Change Order Memorandum

Project Name Margate Boulevard Crosswalk and Landscape Improvements
Date 12/17/2025 Change Order No. 4 Project No. 21-0089.00012
Contractor FG Construction

Project Name: Margate-Crosswalk and Landscaping Improvements

CO No.: CO004

DRAWING NUMBER
RI-4
15 OF 54

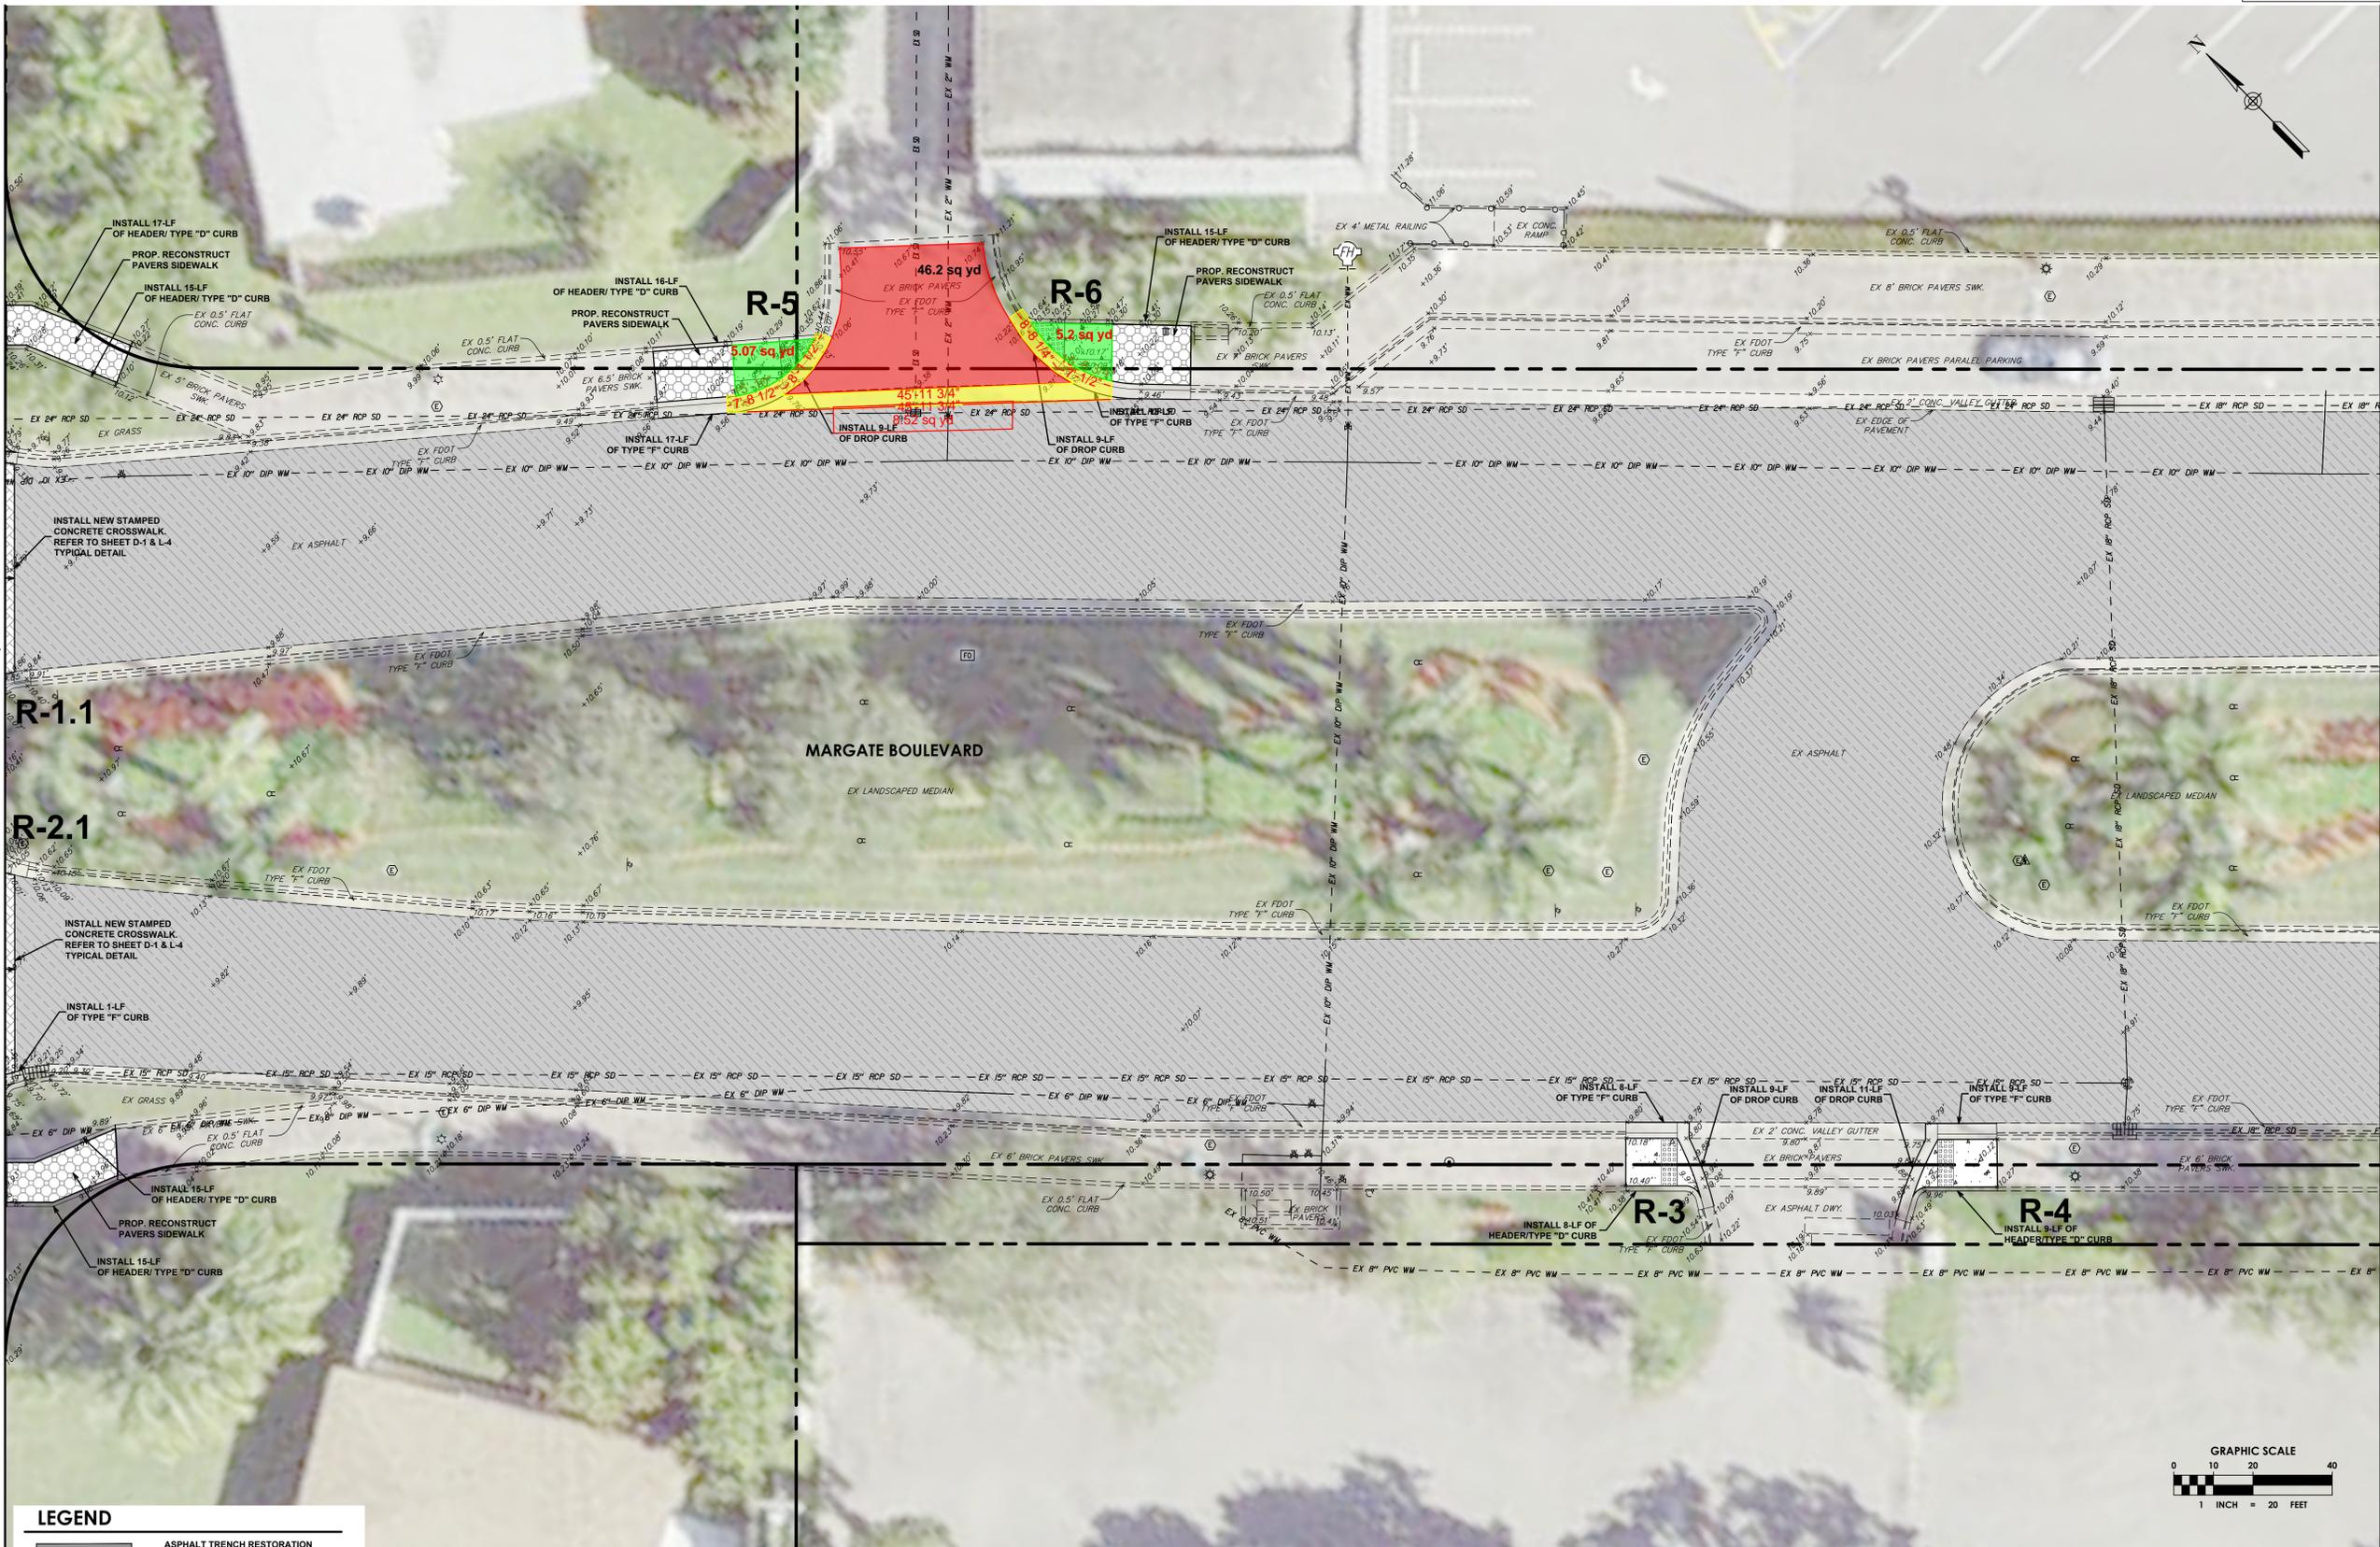
Existing high points are present at the transition between the valley gutter and F-curb along Margate Boulevard. In order to maintain ADA compliance and tie into the surrounding grades, Ramps R-5 and R-6 were constructed to match these existing high points. As a result of the existing roadway and gutter geometry, elevated points occur at both corners of each ramp closest to Margate Boulevard. In addition, the existing catch basin located between R-5 and R-6 exhibits signs of settlement at its base, with associated asphalt cracking and surface deflection. The combination of the existing high points and localized subgrade settlement around the catch basin is contributing to ponding within the storm gutter and around the inlet. Furthermore, the cross slope of the existing paver driveway exceeds the maximum allowable 2% cross slope.

Scope: Remove and Replace ramps R-5 & R-6 and remove existig paver driveway. Regrade the driveway subgrade and base to a 2% cross slope. Address the existing catch basin settlement by removing and recompacting the surrounding material, relocate catch basin grate to align with valley gutter, followed by milling and resurfacing of Margate Boulevard as required

Remove and reconstruct ramps R-5 and R-6, remove the existing paver driveway connecting the two ramps, and remove the ~ 50 LF portion of valley gutter adjacent to the pavement. Regrade the driveway subgrade and limerock base to provide a maximum 2% cross slope along the pedestrian crossing centerline. Address the existing catch basin settlement by removing and recompacting the surrounding material, rotating the concrete top slab 180 degrees to provide clearance for existing drainage lines and place the catch basin grate in-line with the valley gutter. This is to be followed by milling and resurfacing of Margate Boulevard as required. The Contractor shall ensure a smooth, level transition between the pavers, gutter, edge of pavement, and valley gutter.
